STAFF REPORT: JUNE 14, 2023 MEETING PH APPLICATION NUMBER: 23-8388 ADDRESS: 1186 EDISON HISTORIC DISTRICT: BOSTON EDISON APPLICANT: LEON HUNTER, III PROPERTY OWNER: HB1 ALTERNATIVE HOLDINGS, LLC DATE OF PROVISIONALLY COMPLETE APPLICATION: MAY 22, 2023 DATE OF STAFF SITE VISIT: MAY 30, 2023

# SCOPE: DEMOLISH GARAGE, ERECT GARAGE, REPLACE WOOD WINDOWS

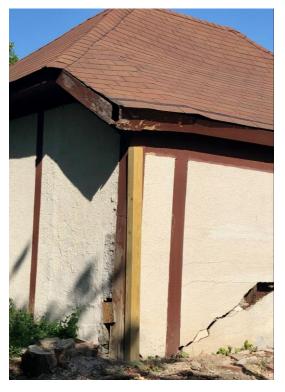
• There was a painter at the house on the day of my site visit; the current color palette is off-white stucco and black windows and trim. The repainting has not been submitted to HDC staff for review.
